CASE COMMENT REPORT

CASE NO. UDP-S26007

| PROJECT NAME | Marlowe Cypress Creek |
| REQUEST | Four (4), New Residential Buildings With 310 Units, And 2,817 Square Feet of Restaurant Space Inclusive of 483 Square Feet of Outdoor Seating |

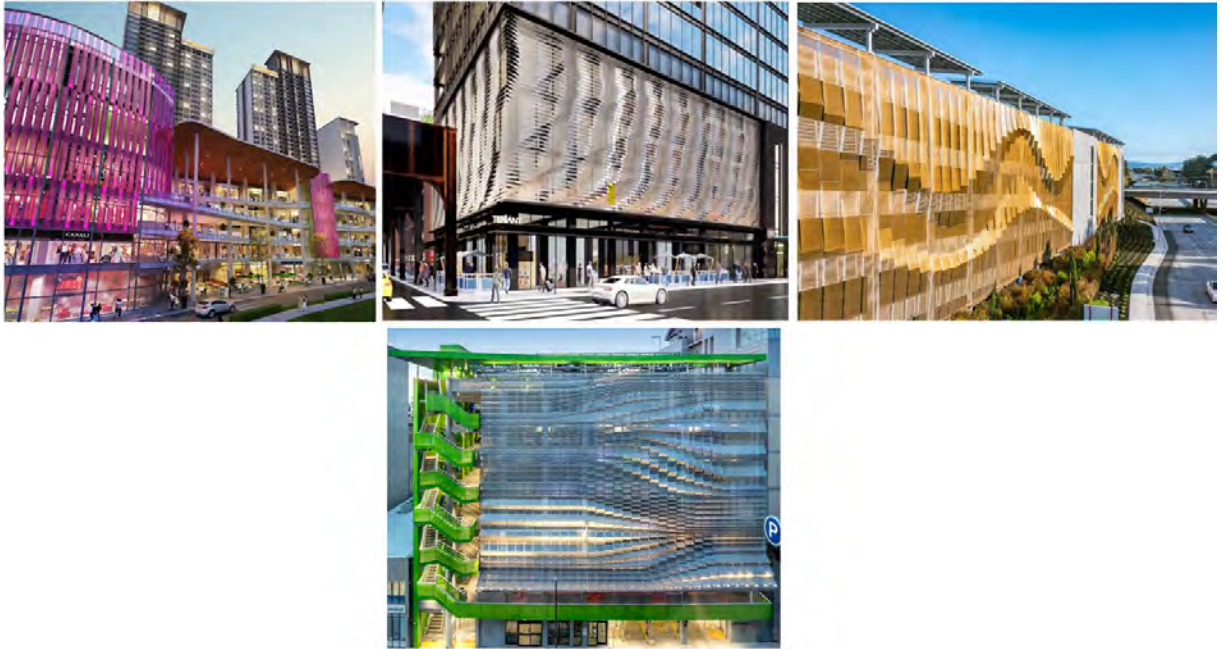
13. UMP, Master Plan Framework 4.6, mobility concept depicts one (1) secondary street and one (1) tertiary street to create a street grid for this area that would include street cross section for on-street parking, sidewalks, travel lanes, landscape, pedestrian lighting and 10-foot to 20-foot shared use paths. Proposed project does not reflect this layout.

In addition, the tertiary street is within the proposed development site and extends up to Powerline Road (green line). In a meeting with staff, options were presented to improve this portion from NW 6th Way to Powerline Road. One of those options can be to create a greenway that incorporates lush greenery, benches, pedestrian lighting, hardscape, trash receptacles, etc. See image below.

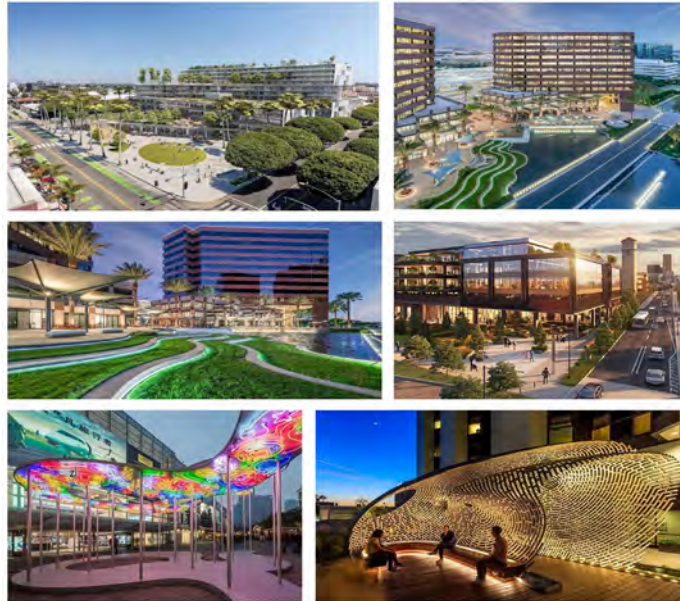
- e. Pursuant to ULDR, Section 47-37B.6.L, Sense of Place Elements. As proposed, the project does not appear to contain elements as described in this section of the ULDR. Provide more information and images of proposed sense of place elements for this project. Building illumination should also be considered as a method for complying with this section. Note:

there is potential to meet both the garage screening and sense of place requirements together based on design. See images below are examples.

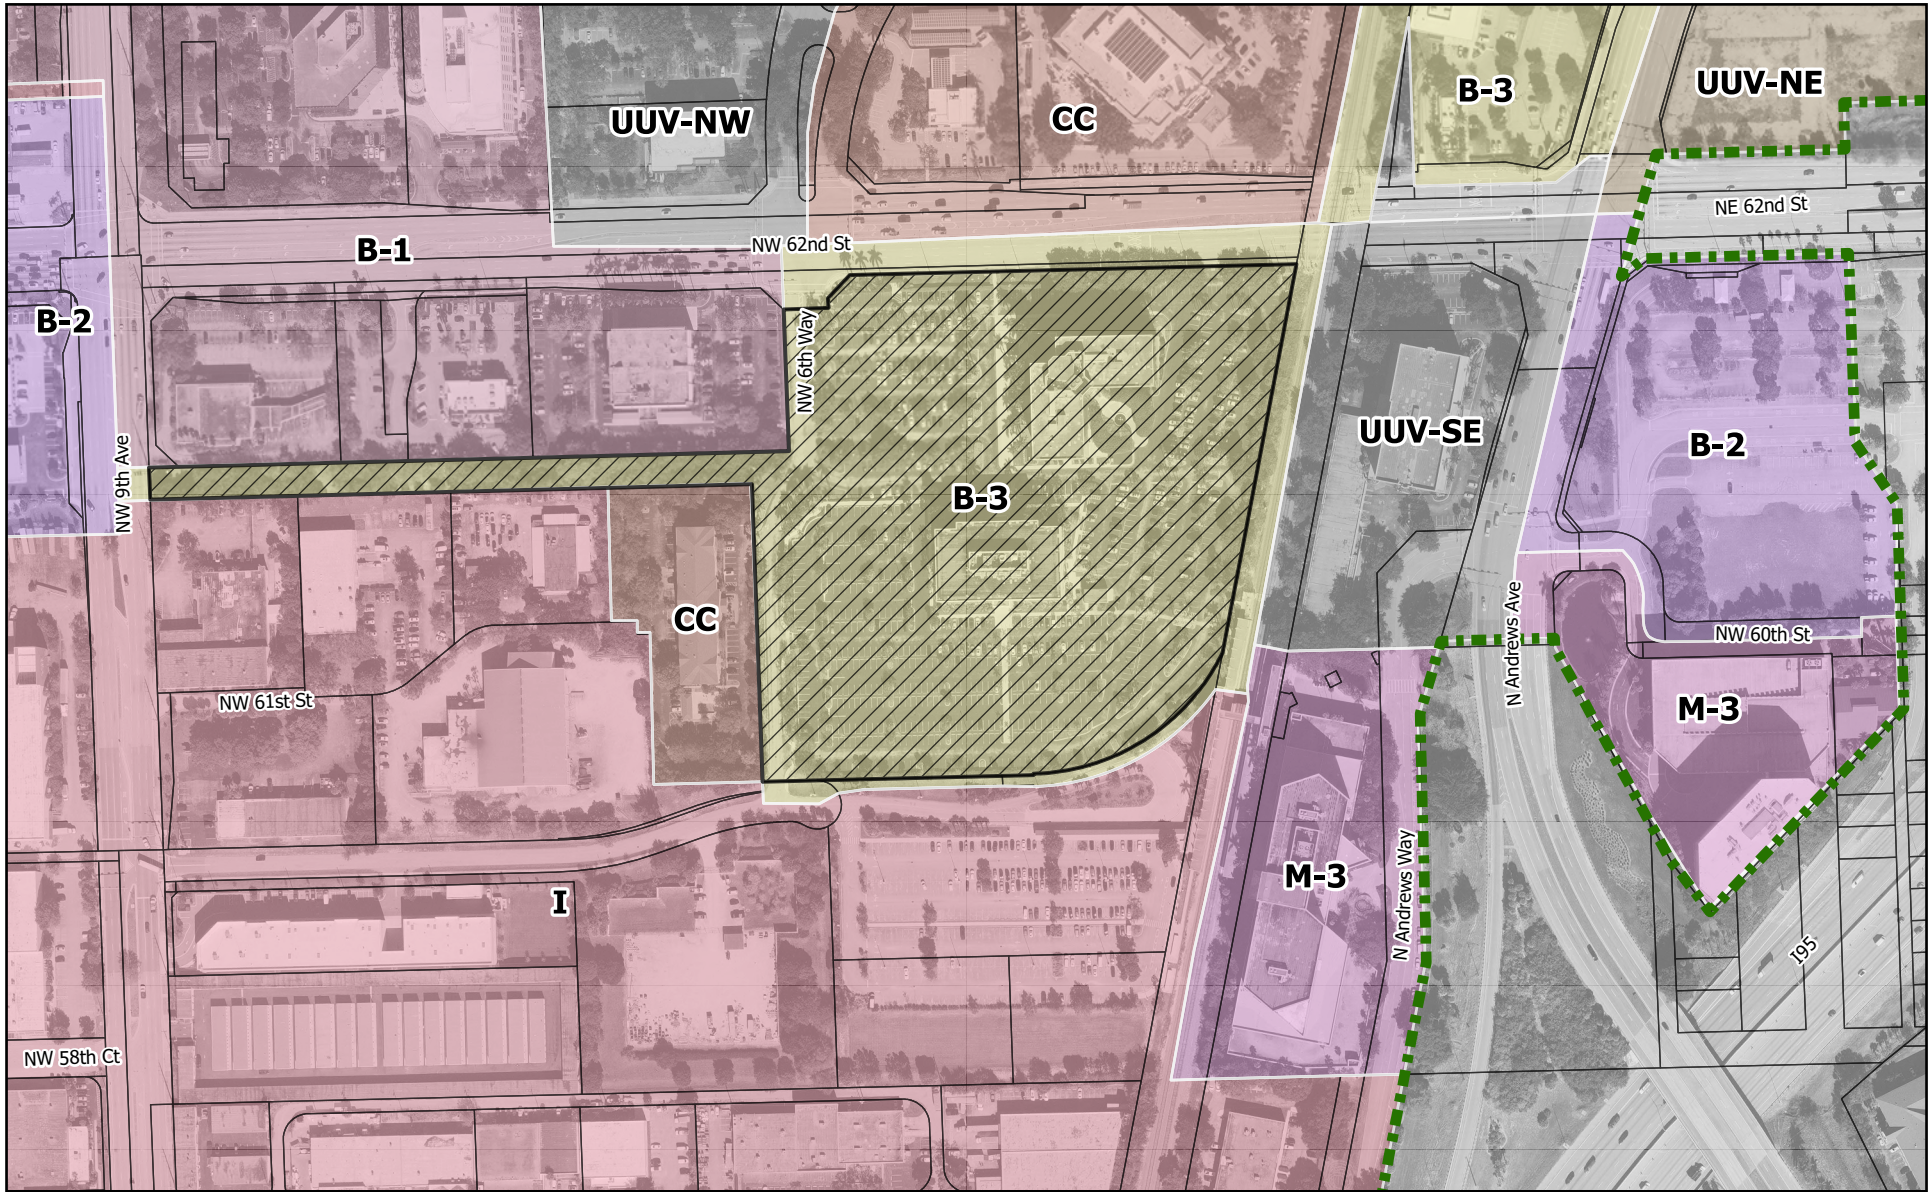
27. Provide a phasing plan depicting any phases of construction and the site improvements included in each phase , if applicable.
28. Provide a preliminary construction staging plan which includes anticipated hours of operation on site, debris mitigation plan, and map indicating where crane operations and employee and/or equipment parking and storage will be placed. A revocable license application and a traffic circulation plan may be required if the sidewalk or right-of-way requires to be closed at any time, which should be filed under a separate application and coordinated through the City’s Maintenance of Traffic (MOT) process with the Transportation and Mobility Department.
29. Ensure the site plan package contains adequate amount of detail drawings and cross sections for: (1) frontages at key points reflecting variations in grade, design, and site elements; (2) the frontage along

Cypress Creek Road and the internal drive on the west and south (3) and other building design features as necessary to demonstrate compliance with Uptown regulations.
